5. PRELIMINARY SITE PLAN REVIEW (File Number JPLN2022-0017) – Proposed Abbey Estates Site Condominium, 4 units/lots, North side of Wattles, West of Rochester, Section 15, Currently Zoned R-1C (One Family Residential) District

**Preliminary Site Plan Approval for a
Site Condominium Plan
For
City of Troy, Michigan**

Applicant:	Steve Muci
Project Name:	Abbey Estates
Plan Date:	May 10, 2022
Location:	571 and 589 Wattles
Zoning:	R-1C, one-family attached residential
Action Requested:	Preliminary Site Condominium Approval

PLAN:
Landscape Plan

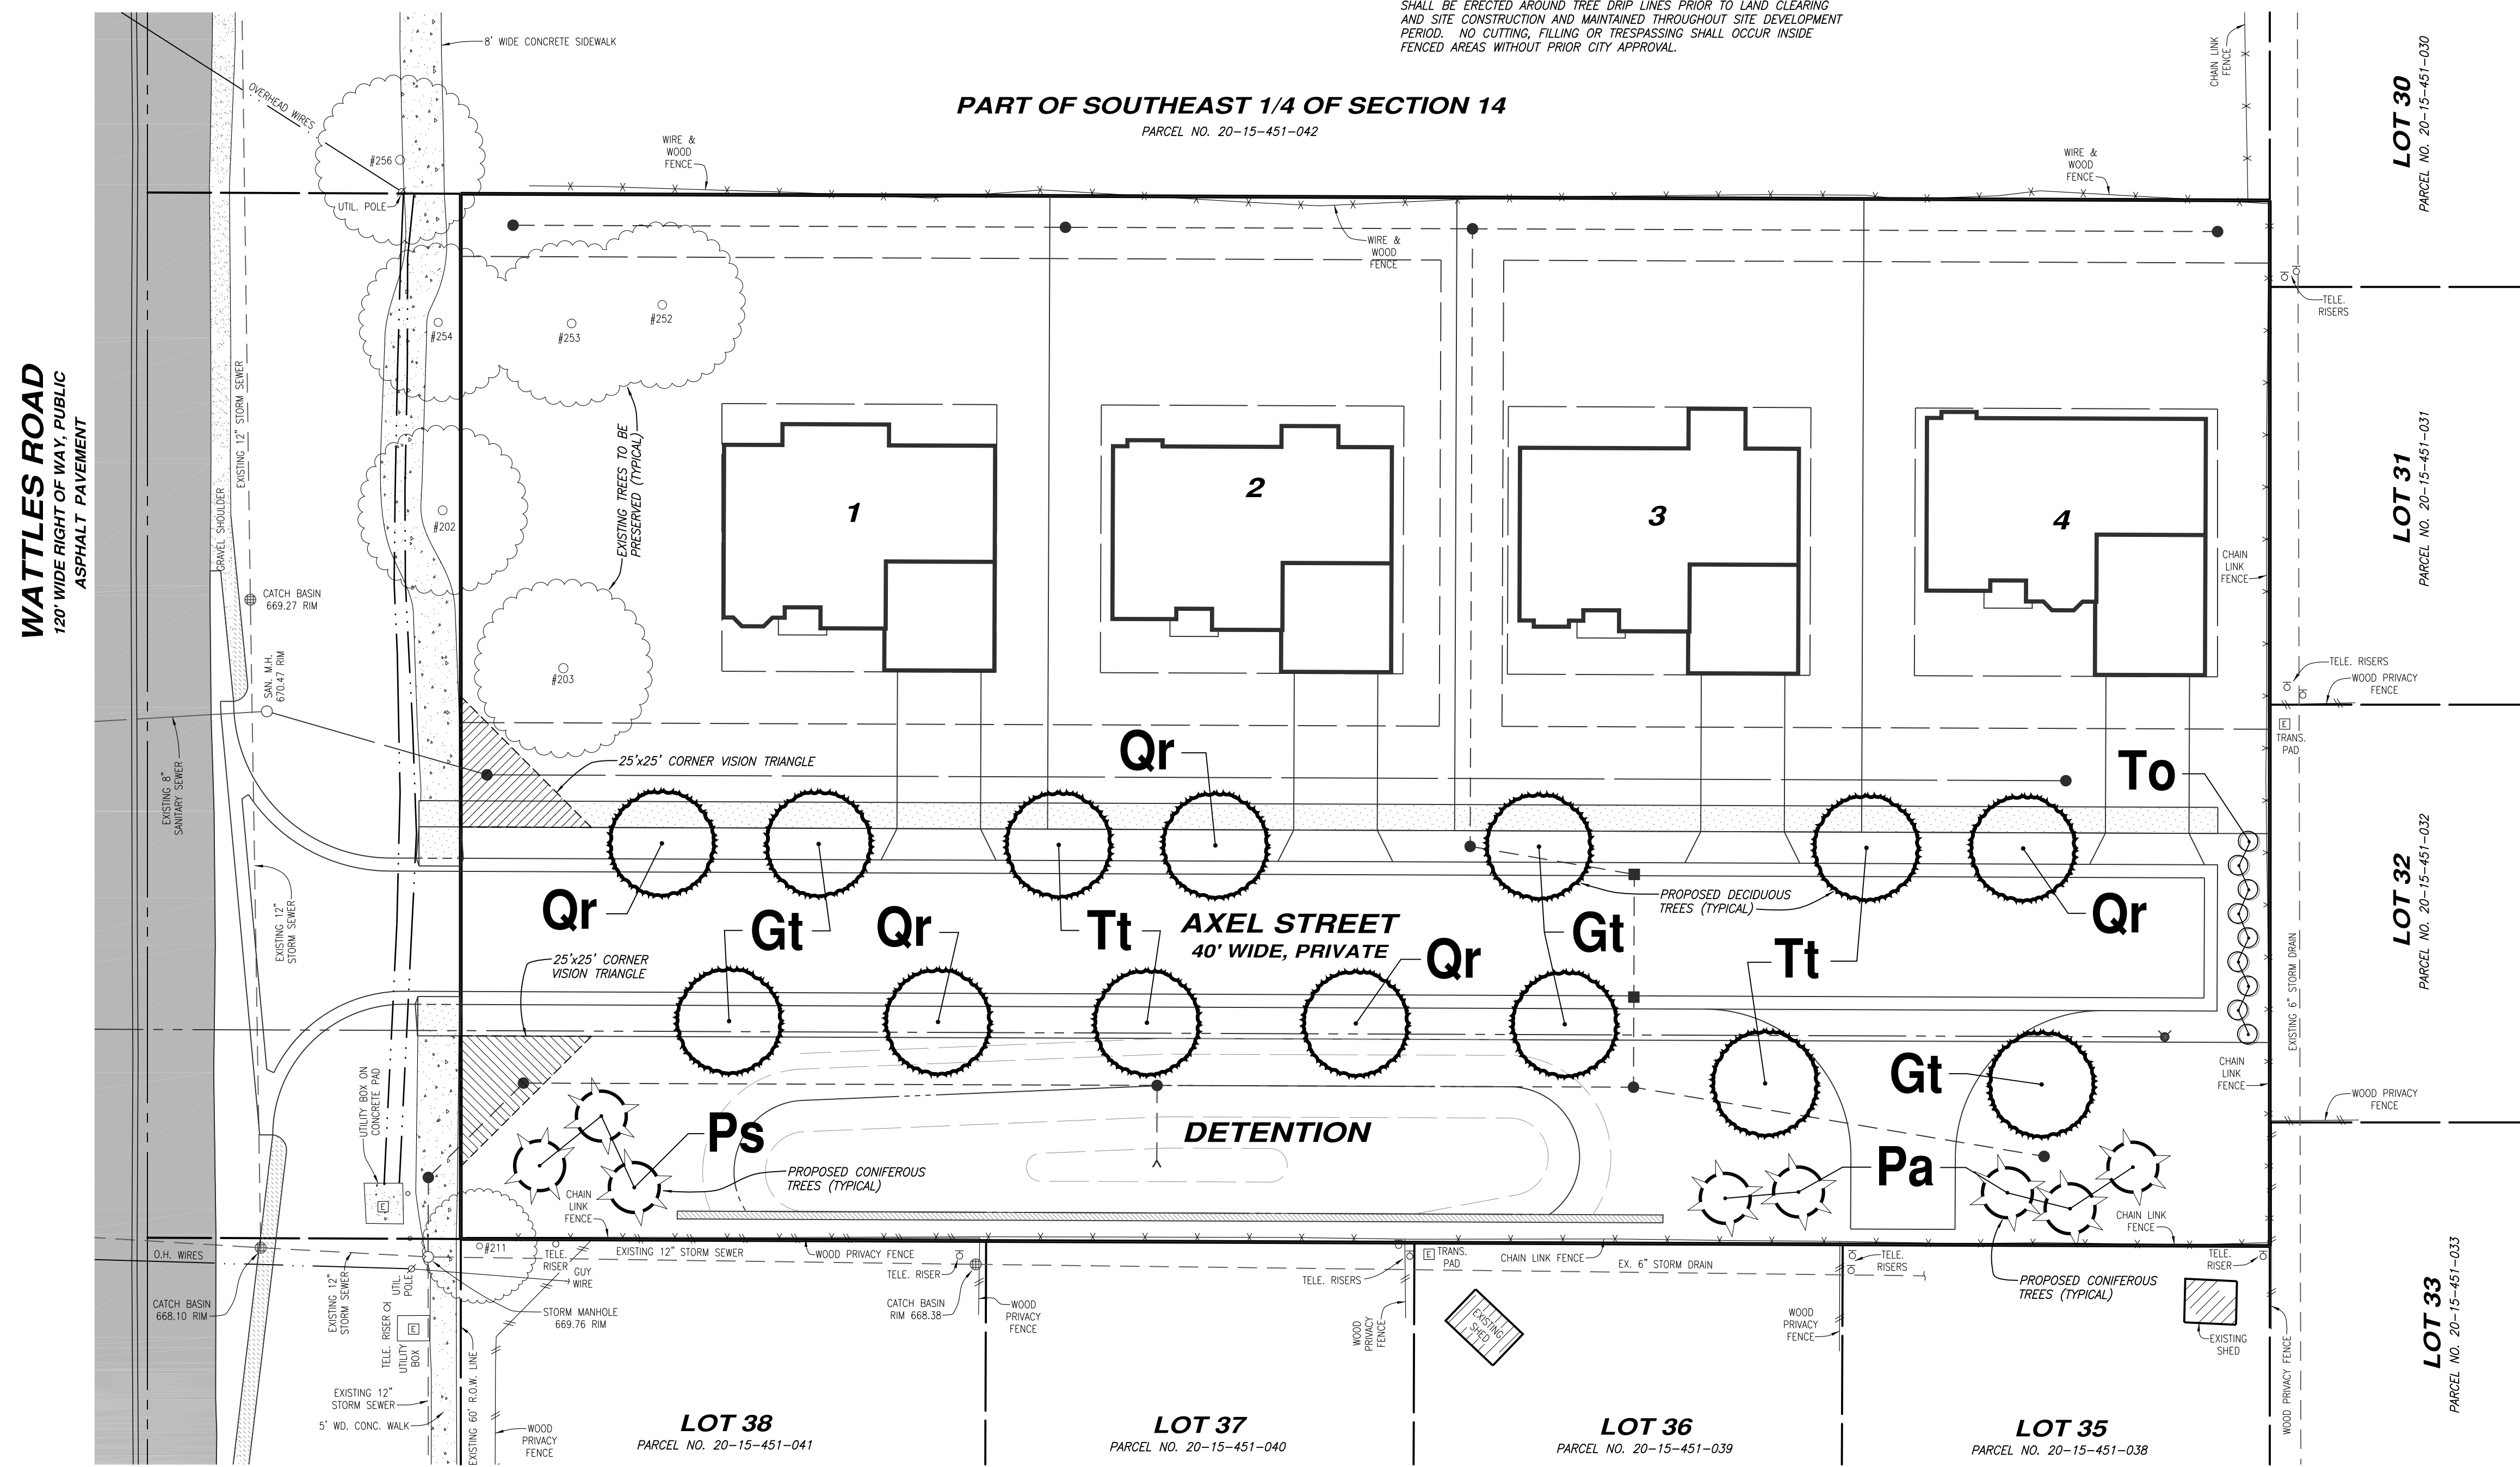
Landscape Plan not stamped by Landscape Architect.

Applicant is required to plant 16 trees. 16 trees equate to 40 caliper inches. The applicant is proposing to preserve two (2) landmark trees along the Wattles Road frontage. These trees are in the ROW. The total caliper inches of those two (2) trees are 40 inches. To plant the required trees, the applicant would have to remove those two (2) mature trees and replant with smaller trees. The applicant is seeking relief to keep these trees rather than remove and use those caliper inches to count towards their planting requirement. Please note that because these two trees are located offsite (in ROW), we did not count their preservation to the woodland mitigation credit. Please note that if the Planning Commission allows these trees to count their planting requirement and if these trees do not survive during the construction

period of this development, the applicant would be required to remove trees and plant the required street trees.

Items to be Addressed: 1). Planning Commission to consider allowing offsite tree preservation to street tree requirement; and 2). Have plan prepared by licensed landscape architect.

1. Confirm roof height.
2. Provide materials.
3. Resubmit landscape plan stamped by Landscape Architect.
4. If trees two (2) landmark trees in ROW die during the construction phase of the development, applicant is required to replace street trees as required in the Zoning Ordinance.
